Ordinance 20033

AN ORDINANCE approving the City of Redmond Water System Plan dated May 2025.

SECTION 1. The city of Redmond Water System Plan dated May 2025,

Figure 2-1. Retail Service Area and Adjacent Purveyors

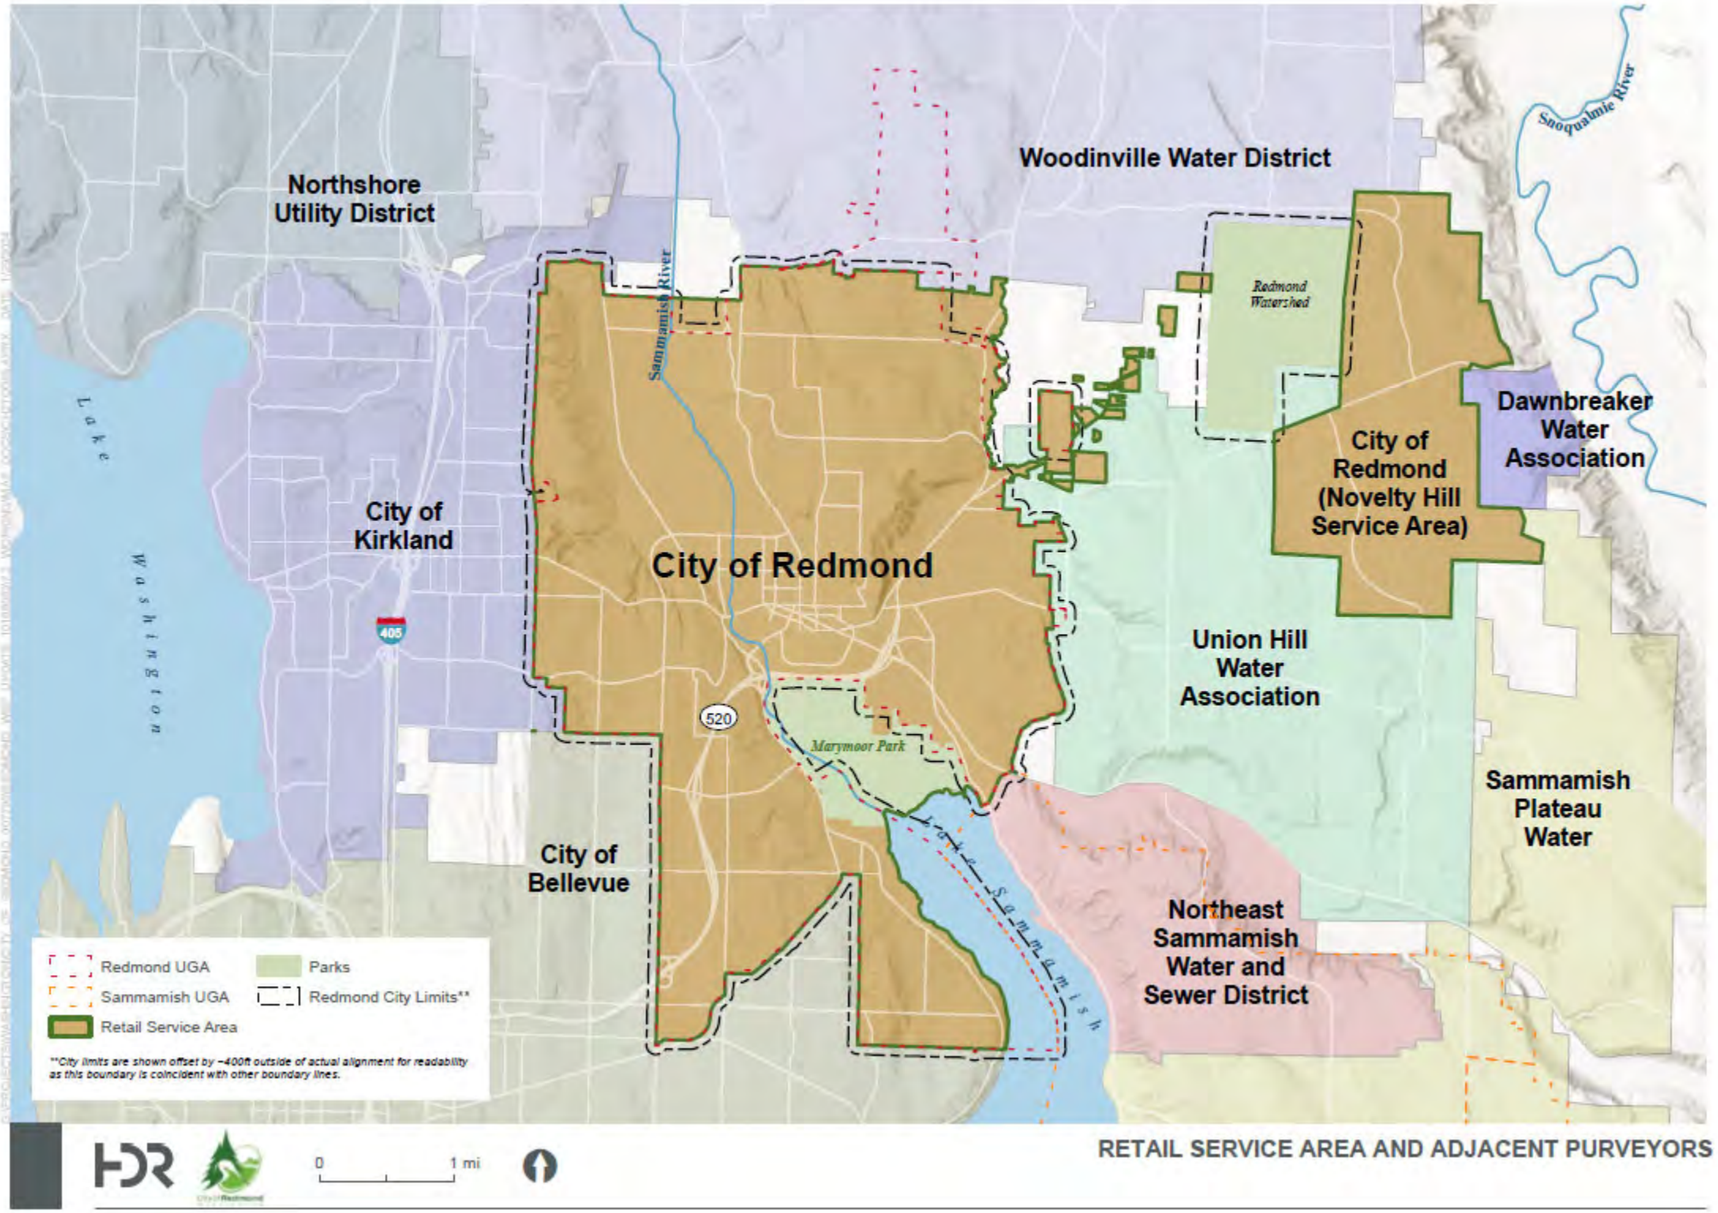
Comment No.	Comment	Response
1	Service Area Boundary: Please correct the City of Kirkland Retail Service Area boundary shown on Figure 2-1. Please see the encircled area on the attached Kirkland Existing Water System Map.	Figure has been revised per the comment.
2	South and North Rose Hill Ownership Percentages. Table 3-5, Page 3-35, shows Redmond's contractual ownership of the South and North Rose Hill Reservoirs as 21.5% and 29.2%, respectively. It appears these ownership percentages are from the 1993 Rose Hill Assumption Agreement. The 1997 Interlocal Operations and Maintenance Agreement, amended in 2005, shows that Redmond owns 29.4% of the Rose Hill South Reservoir and 34% of the North Rose Hill Reservoir. The percentage used to define the contractual storage available to the City of Redmond may affect the analyses and text contained in Chapters 10 and 12. Please see the highlighted portions of the attached Interlocal Operations and Maintenance Agreement.	Table 3-5 has been updated, and associated updates in other chapters have also been made.

5) Figure 2-1. Retail Service Area and Adjacent Purveyors. It is difficult to identify the Retail Service Area as the UGA and City Limits overlap with it. Can the map key be revised to identify the Retail Service Area more clearly in conjunction with other map attributes?

6) Section 2.2.1. Novelty Hill Service Area. While Figure 2-1 shows that the Novelty Hill Service Area is not contiguous/detached from other City service areas, the text does not explain why the City was the most appropriate water purveyor to provide water service to the residential developments in unincorporated King County. It would be beneficial to clarify when and why the City expanded its

8) Section 2.3.1. 2016 King County Comprehensive Plan. In review of Figure 2-1, it appears the City's service area encompasses unincorporated areas beyond the Novelty Hill Service area; however, the text doesn't appear to acknowledge this. While there is reference to the UGA, does the City's service area include any unincorporated Rural areas? It appears that Figure 2-3 shows a small portion of the service area being designated Rural area. Please clarify.

11) Section 2.4.1 Retail Service Area Boundaries. The text states that the City doesn't anticipate any major changes to its retail service area in the immediate future, however, the service area may be expanded to provide service to areas annexed into the City. While Figure 2-1 indicates that the unincorporated UGA adjacent to the City is not within the City's Retail Service Area, adding text to this section would clarify this situation. The text should also acknowledge that if the City expands its Retail Service Area, the water system plan would need to be amended to modify Figure 2-1 and update other appropriate text.

12) Section 2.4.1 Retail Service Area Boundaries. The text references an area that the City provides water service to that is not within and will not be included in its service area. The text references Figure 2-1 to identify the location of this area, however, in review of the figure, it doesn't appear this area is identified. The text also references discussions with Union Hill Water District and Woodinville Water District for future service discussions. Is there a timeframe in which this issue will be resolved? Please clarify?

13) Section 4. Planning Data and Demand Forecast. The text states that Redmond retails water in two areas; the City Service Area and the Novelty Hill Service Area, however, in review of Figure 2-1, it appears that there are other unincorporated areas within the City's Retail Service Area, including the unincorporated area north of NE 116th in the proximately of 184th Ave. NE. Please clarify.

Figure 2-3. King County Land Use in the Redmond Area

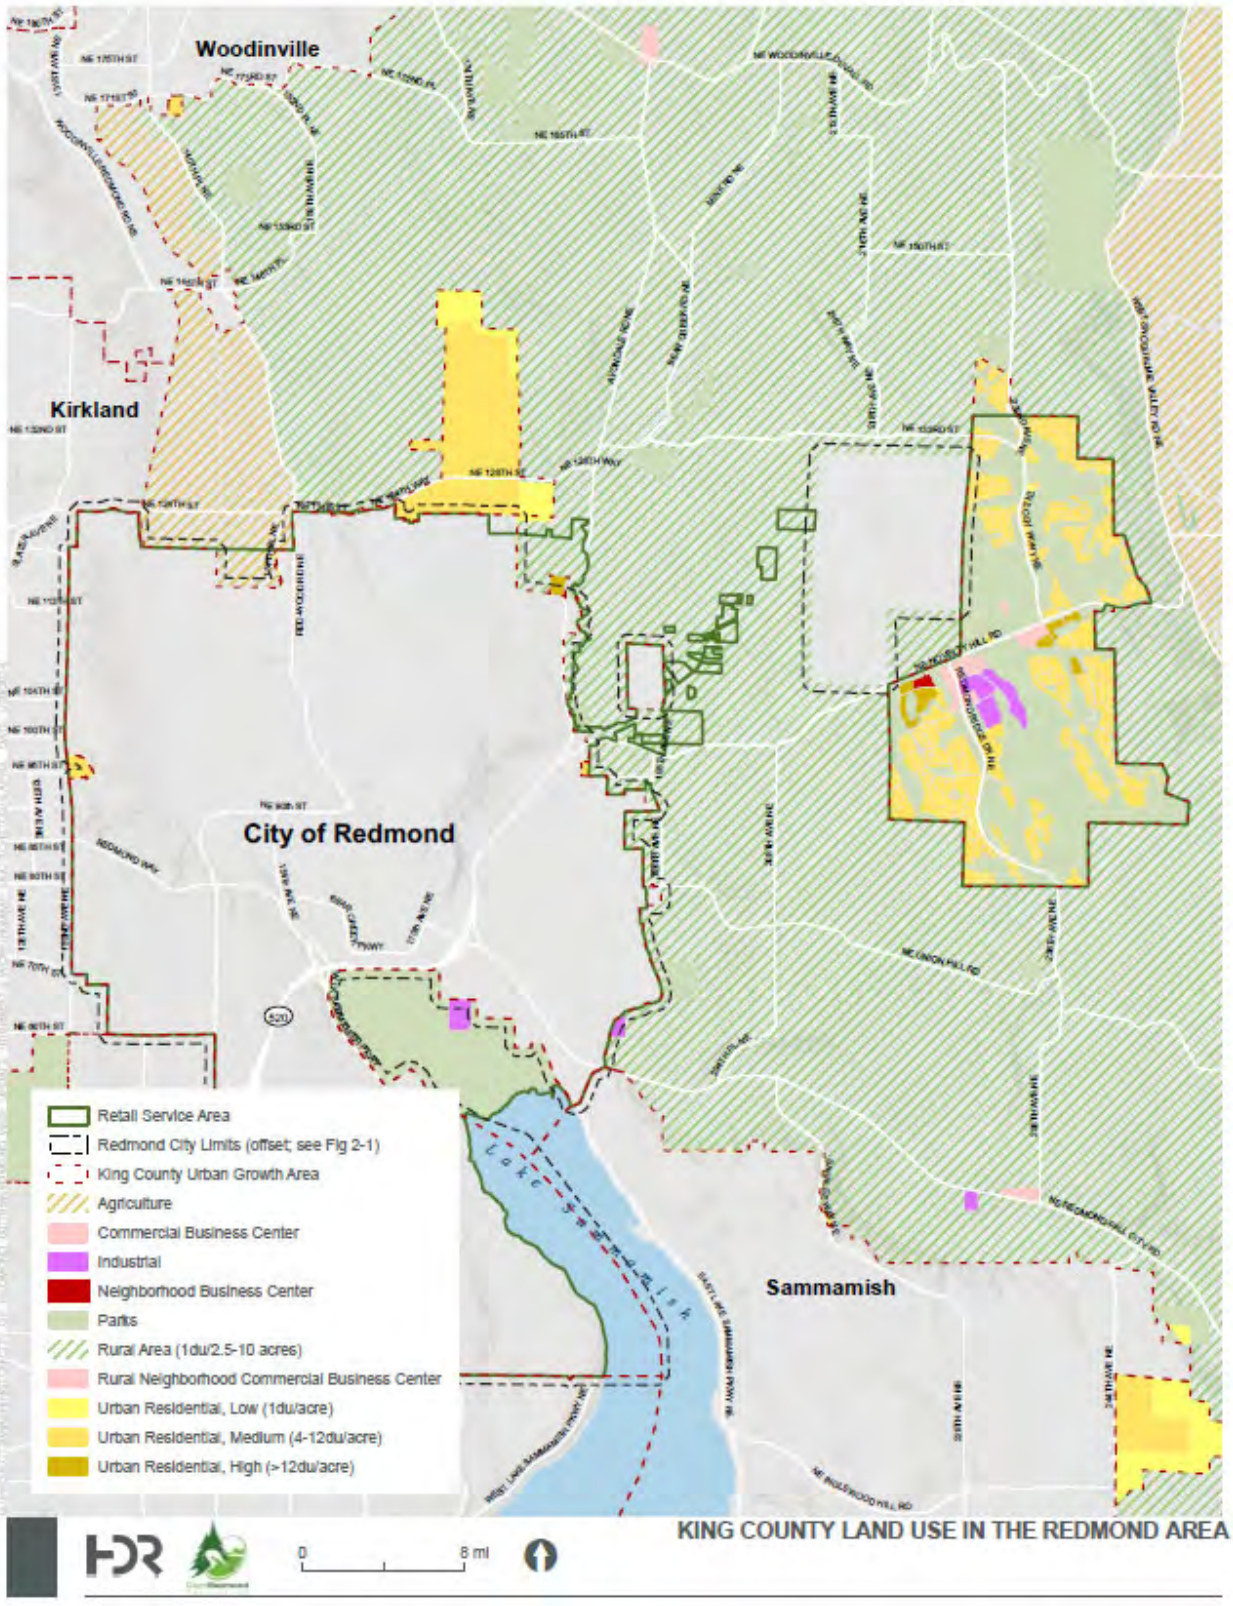
7) Section 2.3.1. 2016 King County Comprehensive Plan. The text provides a detailed description of the County's Comprehensive Plan policies and identifies adopted land use designations on Figure 2-3., however, it is appropriate to also provide the acreage associated with each land use designation and identify the development status of the acreage (i.e., vacant, developed, underdeveloped).

Figure 2-4. Redmond Comprehensive Land Use Plan

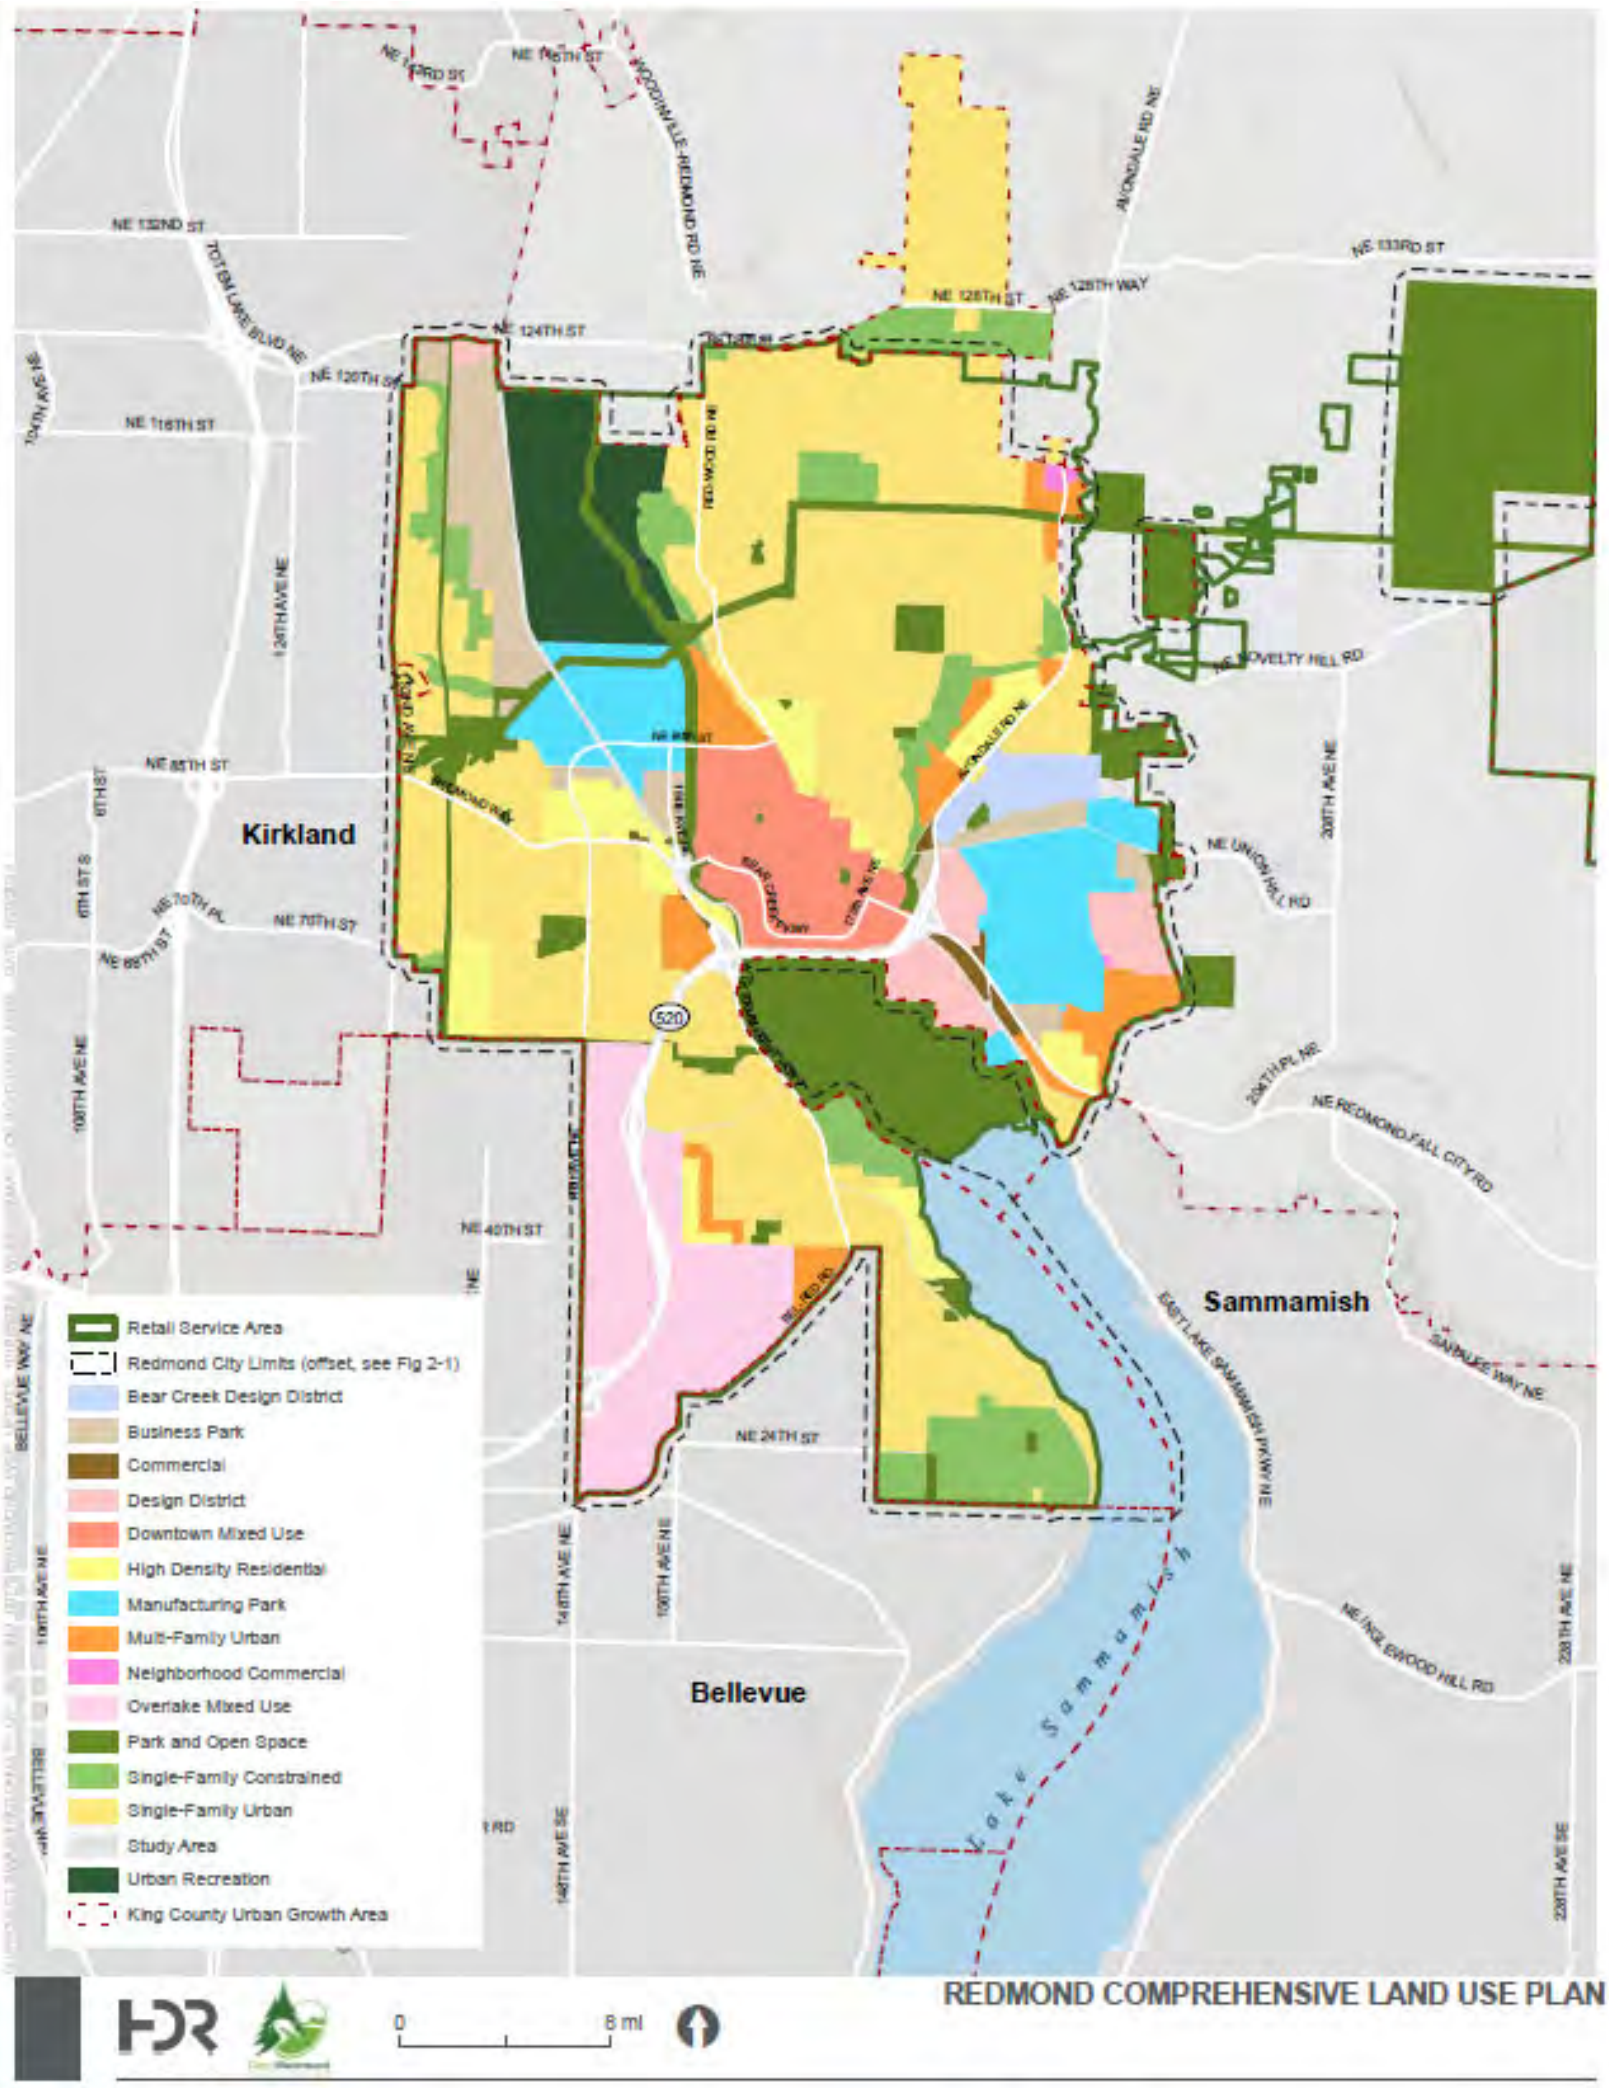
10) Figure 2-4 Redmond Comprehensive Land Use Plan. It is difficult to identify the Retail Service Area as the UGA and City Limits overlap with it. Can the map key be revised to identify the Retail Service Area more clearly in conjunction with other map attributes?

10	Figure 2-4 Redmond Comprehensive Land Use Plan. It is difficult to identify the Retail Service Area as the UGA and City Limits overlap with it. Can the map key be revised to identify the Retail Service Area more clearly in conjunction with other map attributes?	Figure revised, as noted in a previous response.
11	Section 2.4.1 Retail Service Area Boundaries. The text states that the City doesn't anticipate any major changes to its retail service area in the immediate future, however, the service area may be expanded to provide service to areas annexed into the City. While Figure 2-1 indicates that the unincorporated UGA adjacent to the City is not within the City's Retail Service Area, adding text to this section would clarify this situation. The text should also acknowledge that if the City expands its Retail Service Area, the water system plan would need to be amended to modify Figure 2-1 and update other appropriate text.	All the Redmond UGA that is not served by the City is already served by other purveyors. Added text to 2.4.1 indicating that the service area may be expanded to provide service to areas annexed into the City in the future <u>that are not currently served by another purveyor</u>. A statement was added that changes to the RSA would require a plan amendment and approval.
